Service Bulletin

Bulletin No.: PI0814

Subject: Steering Shudder (Vibration) During Slow Speed Maneuvers

Models: 2010-2013 Chevrolet Equinox
2010-2013 GMC Terrain
Equipped with Engine RPO LF1, LFW or LFX

2900701

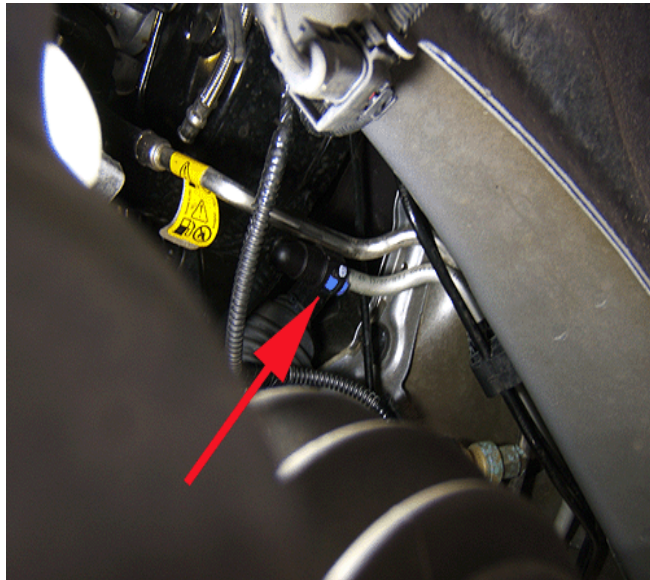
- 3.1. Disconnect the hose from the evaporative emission canister purge solenoid valve located by the base of the throttle body.

2900703

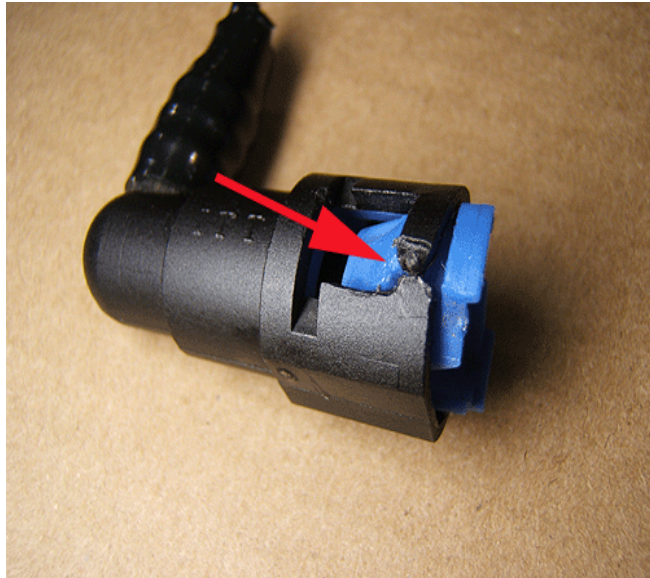
3.2. Disconnect the hose from the chassis to canister evaporative emission line.

2900708

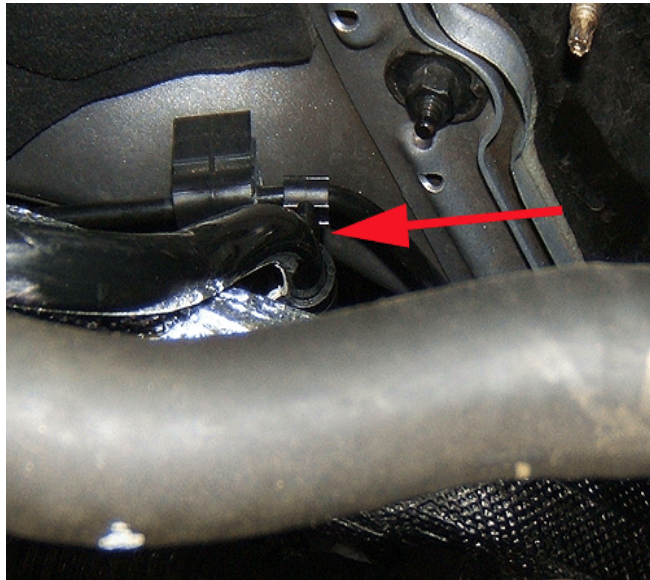
It may be necessary to cut the plastic connector on the hose if the blue plastic retention collar cannot be released. A new connector is part of the new hose assembly.

3.3. Remove the existing hose and install the new hose assembly.

Route the new hose in a way that avoids contact with chassis and body components. Connect both ends of the hose.
